E3630A-03B-S

S E R V I C E N O T E

E3630A Manual DC Power Supply

POSSIBLE SHOCK HAZARD

LOOSE AC MODULE

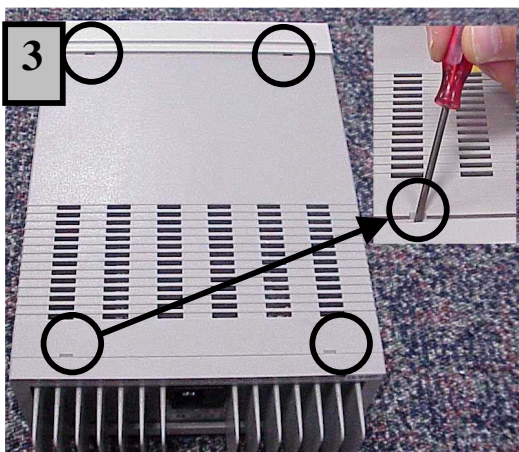
If the AC line cord is forcefully pulled in a side-to-side direction the AC Module can be pulled out of the rear heatsink, exposing the conductors that carry AC line voltage.

1. Make sure linecord is removed from outlet.
2. With linecord securely inserted in AC Module as shown, pull forcibly (2 times) in direction of arrow.

1. If AC Module pulls out from Unit as shown it will need to be replaced.
2. If AC Module remains in place it does not need to be changed. Put a mark on the AC input label in the lower left hand corner with indelible ink to indicate that the AC module has been checked. This label can be found below the AC module.

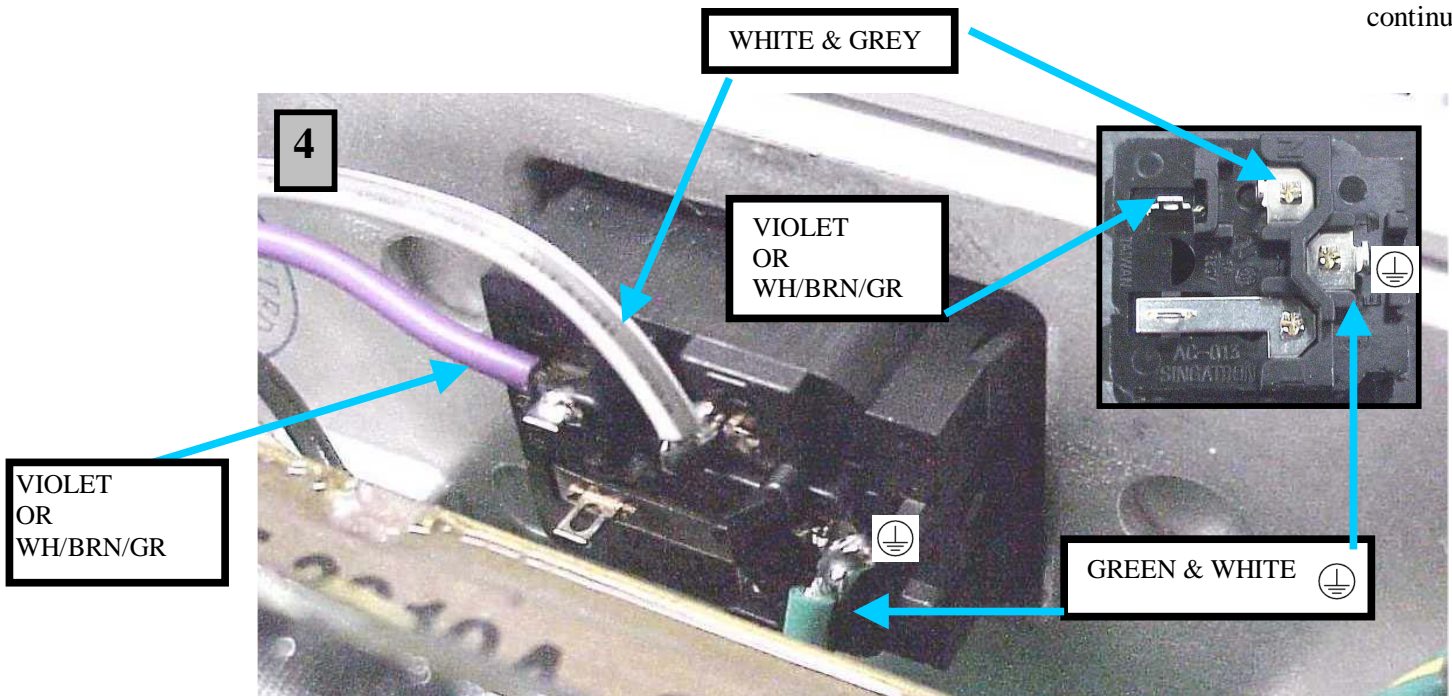
REMOVE COVER by prying Rear Bezel and Front Panel away from Cover in four places as shown. Then lift Cover off unit.

REPLACE MODULE with P/N 5065-6978. Before soldering perform “TEST FOR LOOSE AC MODULE” as shown in picture above. This will confirm that the new Module is secure. Solder wires and **REPLACE FUSE**.

100/120 VAC input use Fuse P/N 2110-0918 (1.6 amp, 250 volt)

230 VAC input use Fuse P/N 2110-0599 (1.0 amp, 250 volt)

CAUTION: WIRING MUST BE CORRECT OR HEATSINK COULD BE AT LINE POTENTIAL.

CAUTION: MAKE SURE SAFETY GROUND \oplus IS ATTACHED TO HEATSINK
